## HISTORIC AND DESIGN REVIEW COMMISSION

April 02, 2025

**HDRC CASE NO:** 2025-070  
**ADDRESS:** 1024 BURNET ST  
**LEGAL DESCRIPTION:** NCB 1660 BLK H LOT E 16.2 FT OF N 120 FT OF 6 & W 39 FT OF N 120 FT OF 7  
**ZONING:** R-6, H  
**CITY COUNCIL DIST.:** 2  
**DISTRICT:** Dignowity Hill Historic District  
**APPLICANT:** Richard Gonzalez  
**OWNER:** Richard Gonzalez/NEXUS SERIES B LLC  
**TYPE OF WORK:** Construction of a rear addition, exterior and fenestration modifications, repair and maintenance, window replacement  
**APPLICATION RECEIVED:** March 14, 2025  
**60-DAY REVIEW:** May 13, 2025  
**CASE MANAGER:** Edward Hall  
**REQUEST:**

1 ROOF PLAN  
1/4" = 1'-0"

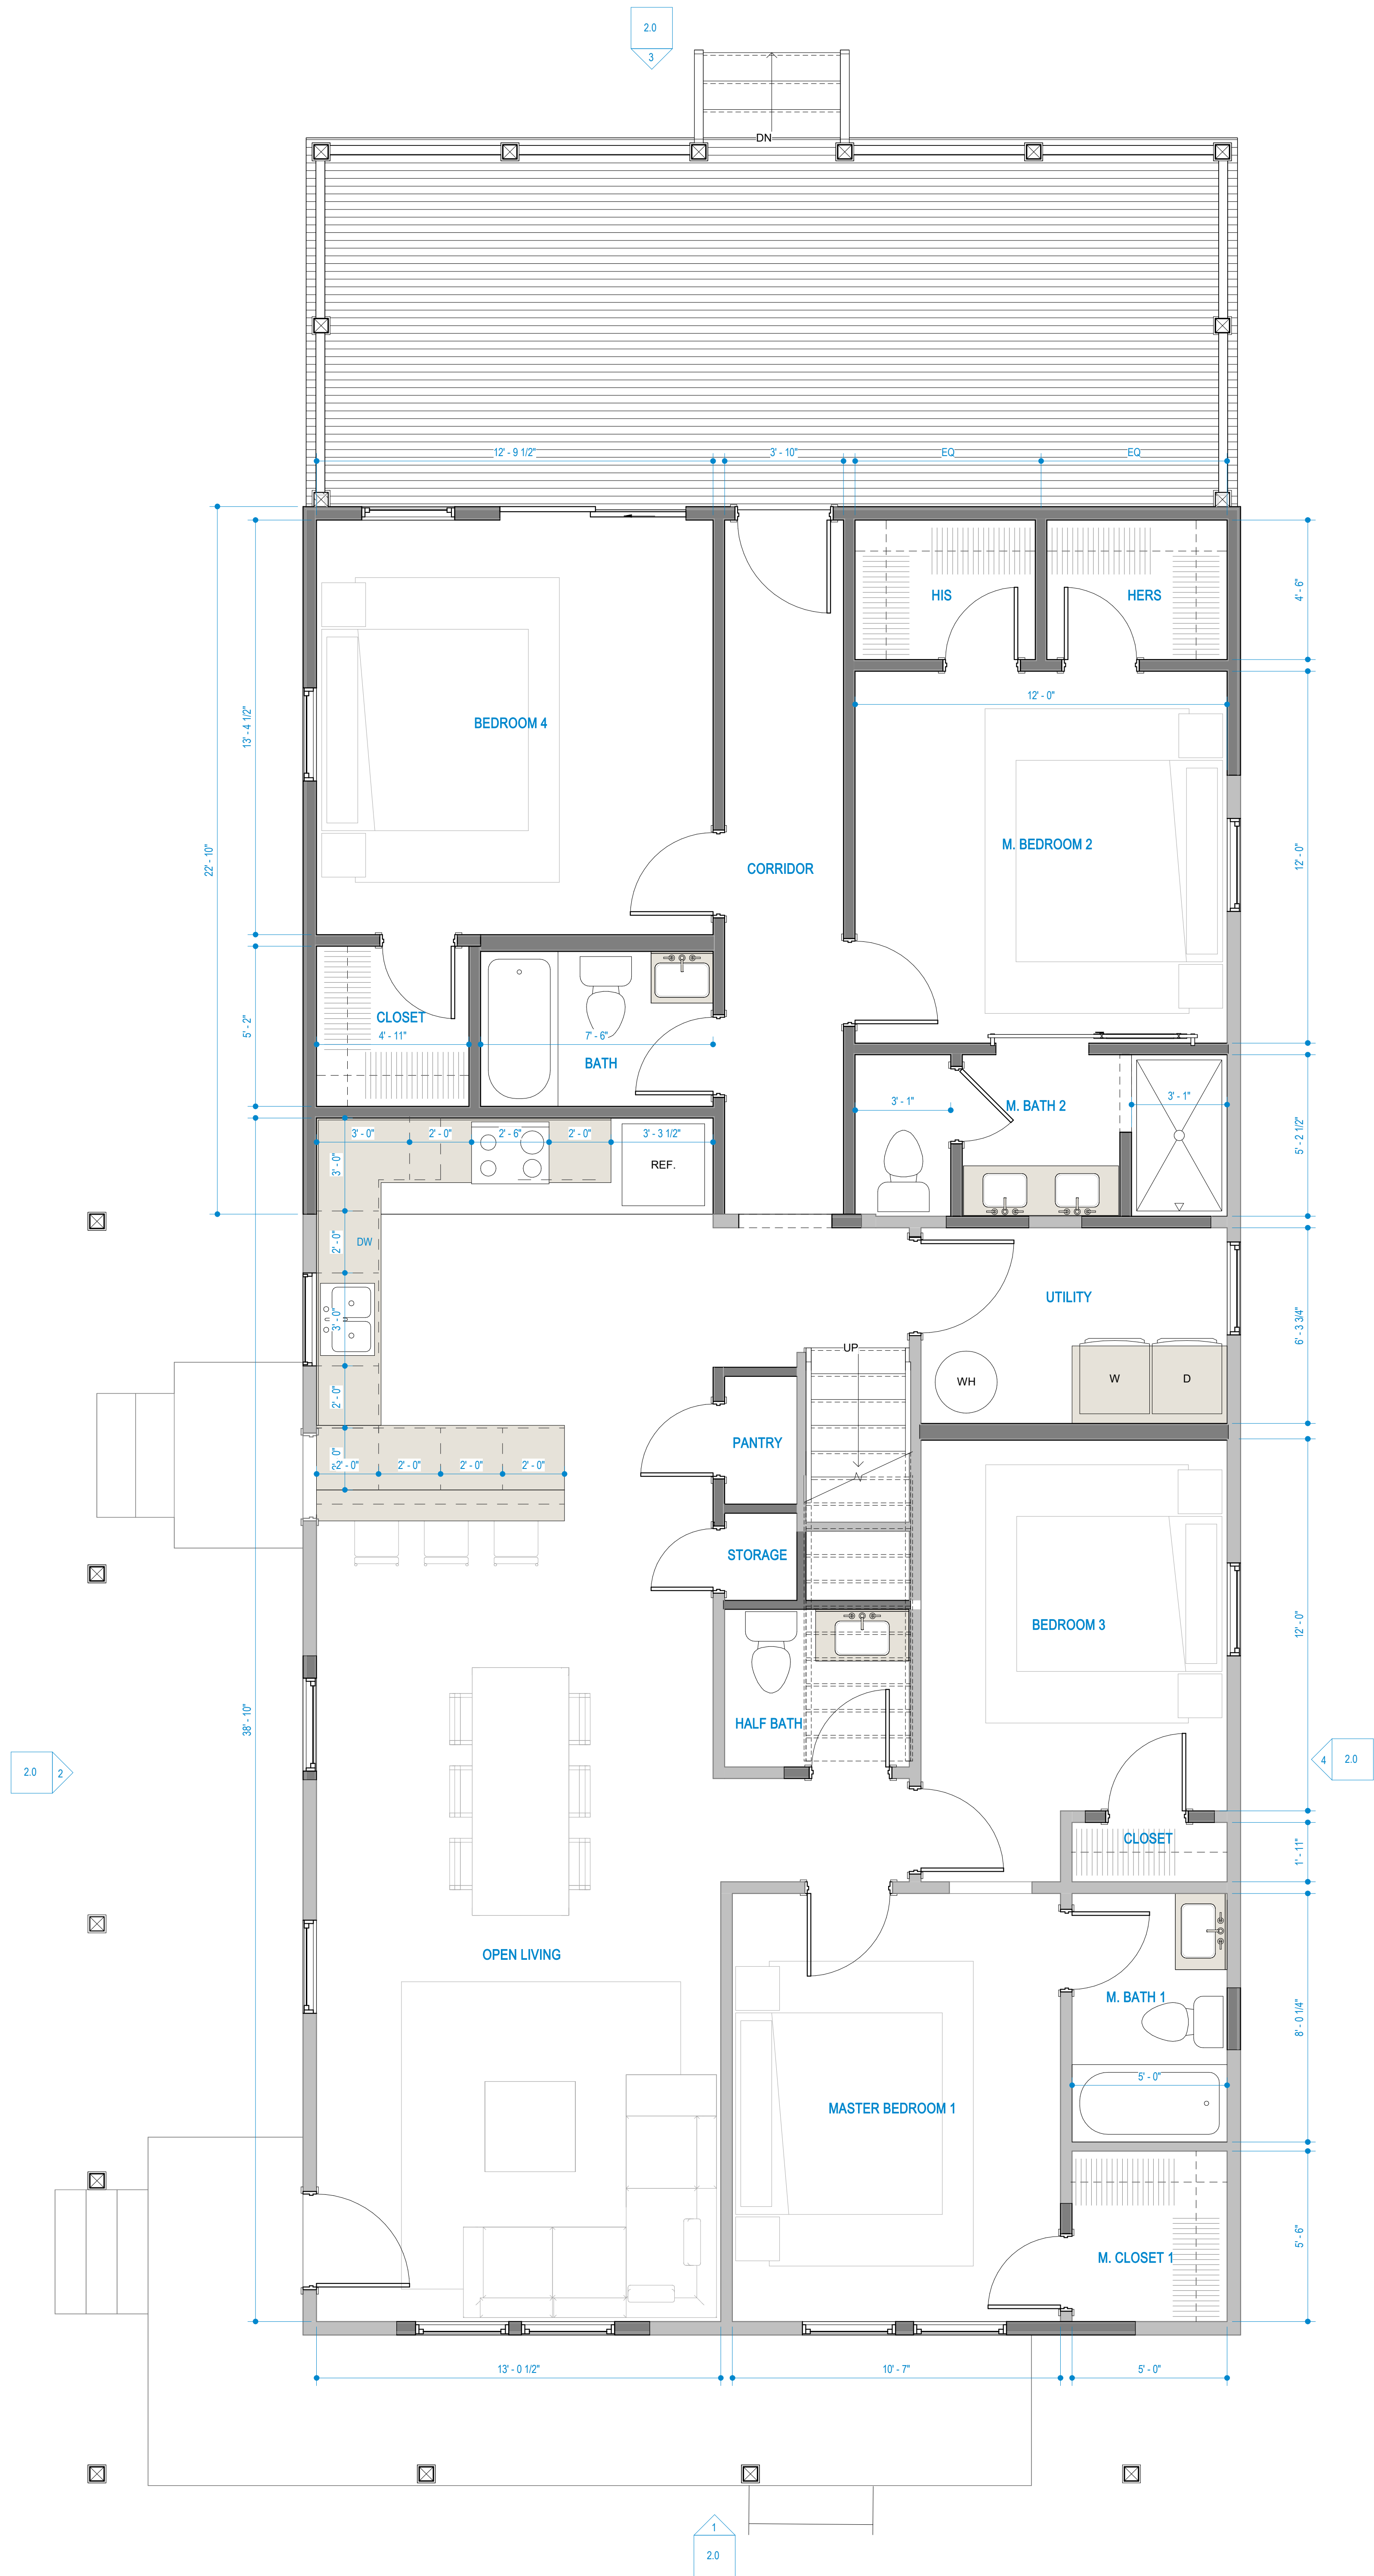
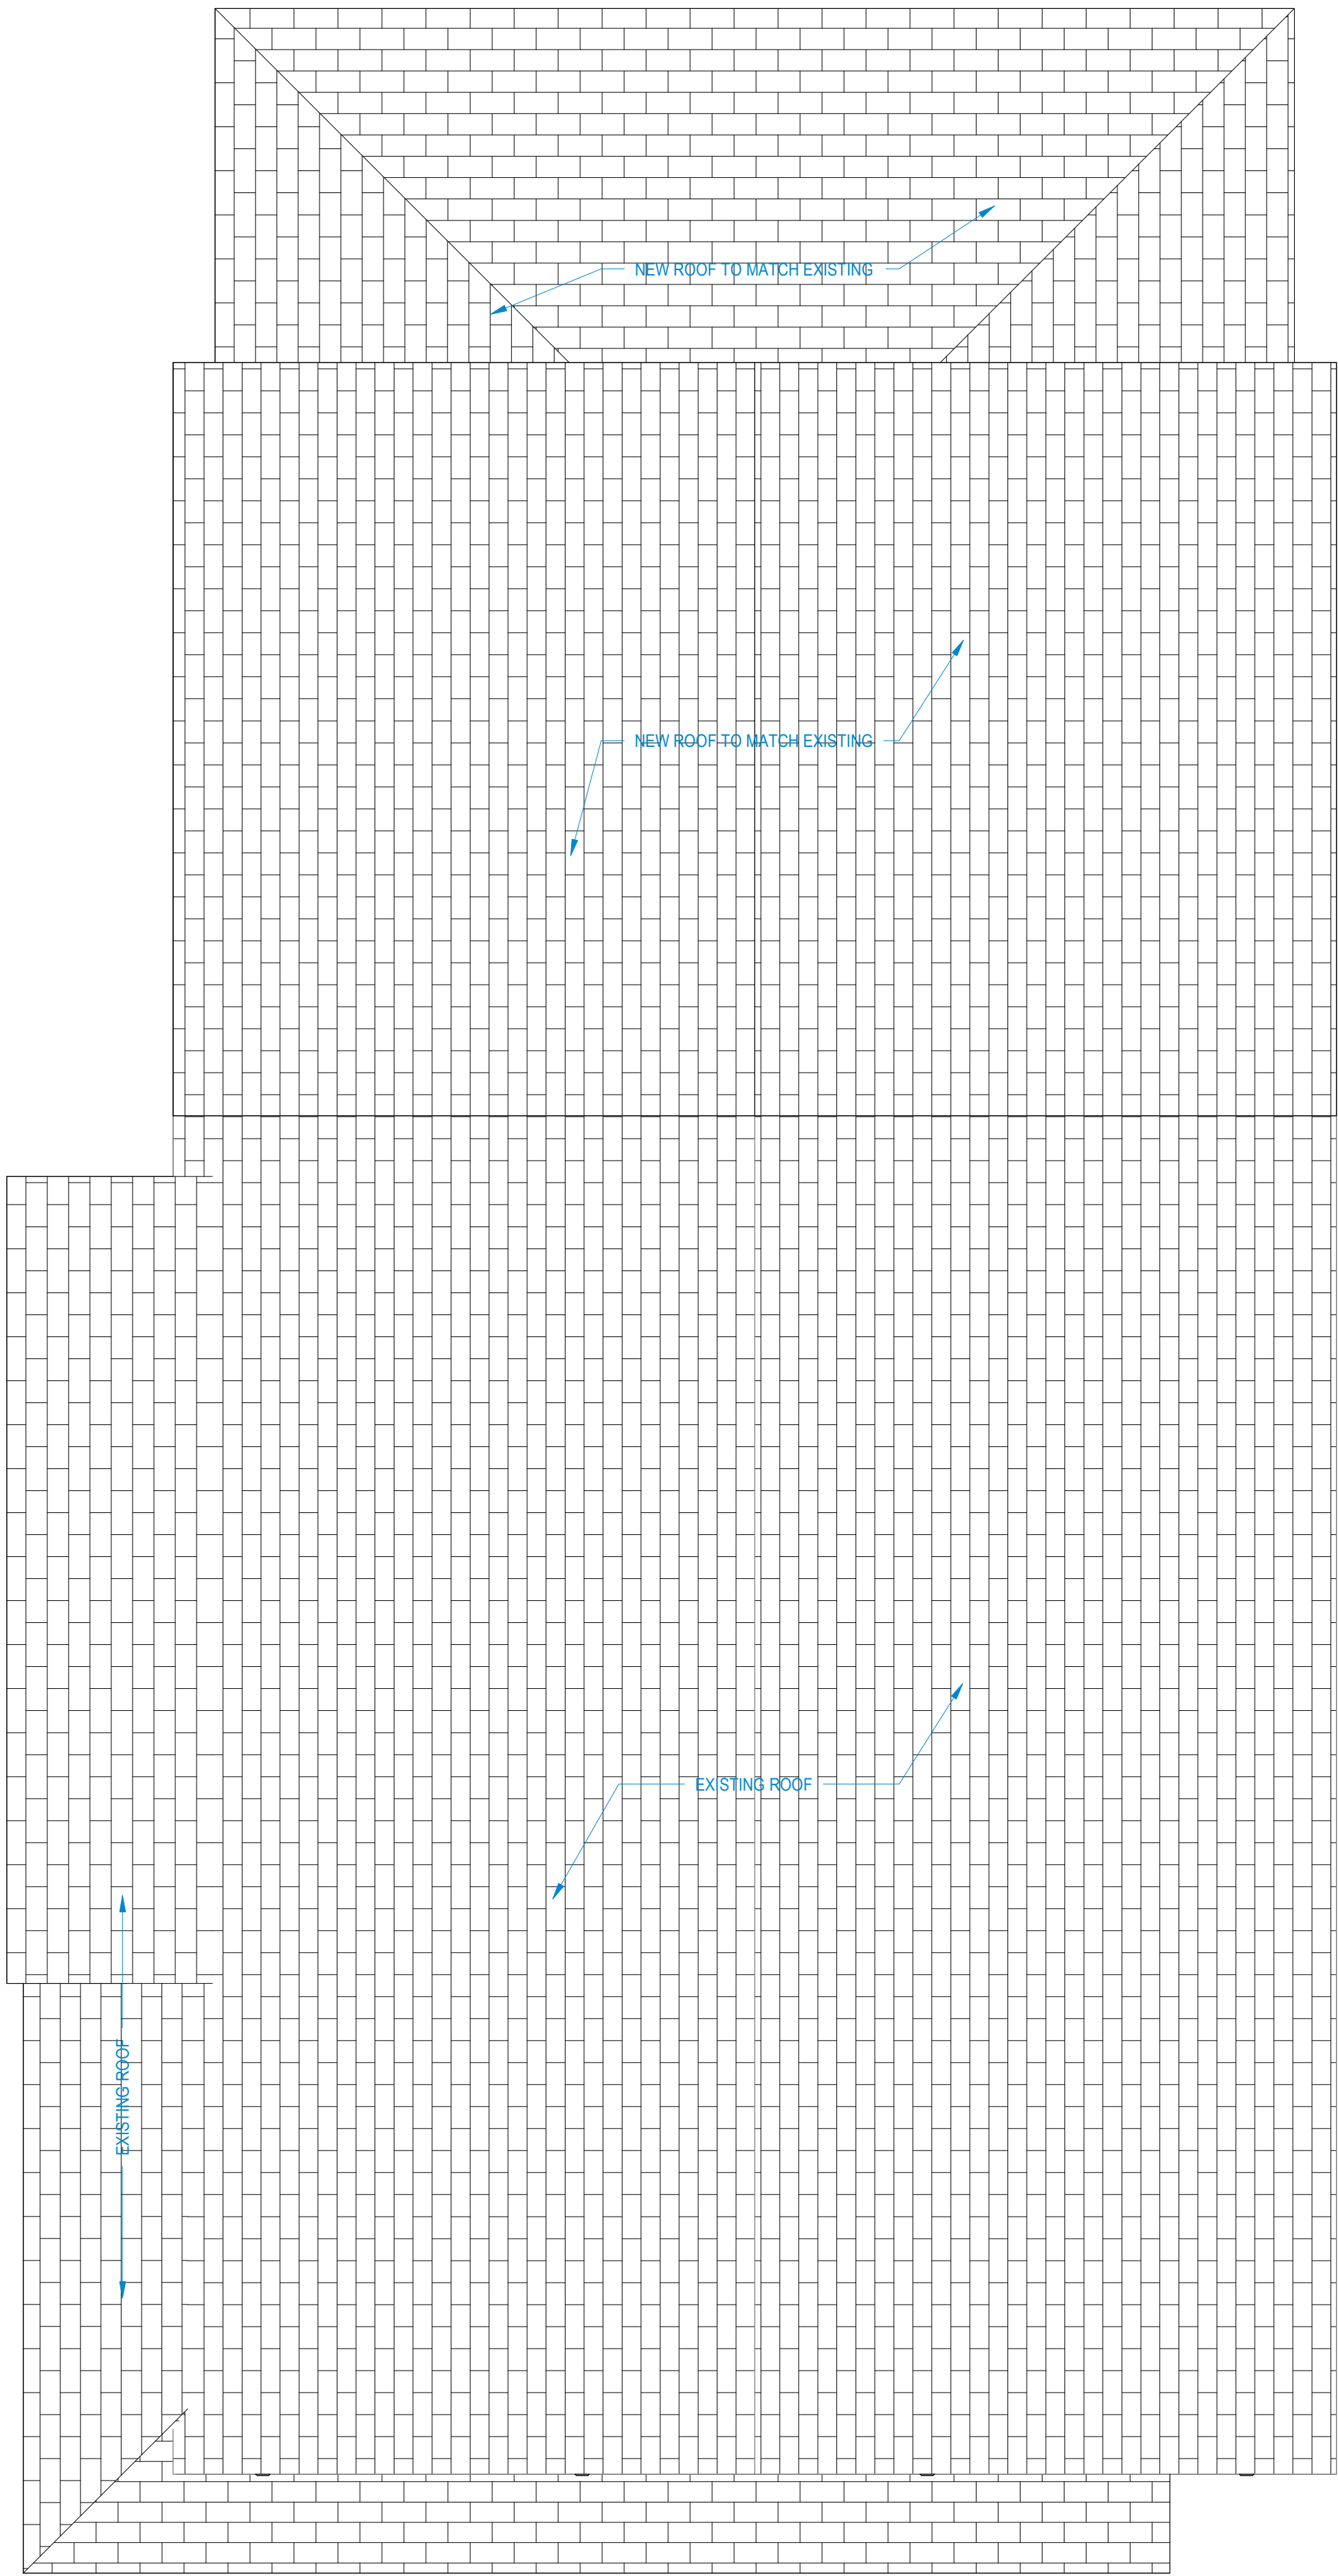
- f. REAR ADDITION – The applicant has proposed to construct a 1-story, rear addition to feature 518 square feet. The proposed addition will feature an asphalt shingle roof, a rear facing gabled roof with a rear covered porch featuring a hipped roof. The proposed addition will encompass an existing, rear wing of the historic structure. This existing rear wing is found on the 1931 Sanborn Map and is contributing to the structure.

- g. REAR ADDITION (Footprint and Massing) – The Guidelines for Additions note that additions should be sited to the side or rear of the historic structure, should be designed in keeping with the historic context of the block, should feature a similar roof form and should feature a transition between the historic structure and new addition. Additionally, the Guidelines note that additions should feature similar architectural details and materials as the historic structure on the block and should not feature a footprint so large as to double the historic structure’s footprint. Generally, staff finds the proposed addition’s footprint and massing to be appropriate; however, staff finds that the proposed addition should either feature a setback from the original structure’s side facades or a vertical trim piece to differentiate the addition from the original structure.

- 4. Staff recommends approval of item #4, the construction of a rear addition based on findings f through i, with the following stipulations:
  - i. That the proposed addition feature either a setback from the original structure’s side facades or a vertical trim piece to differentiate the addition from the original structure.
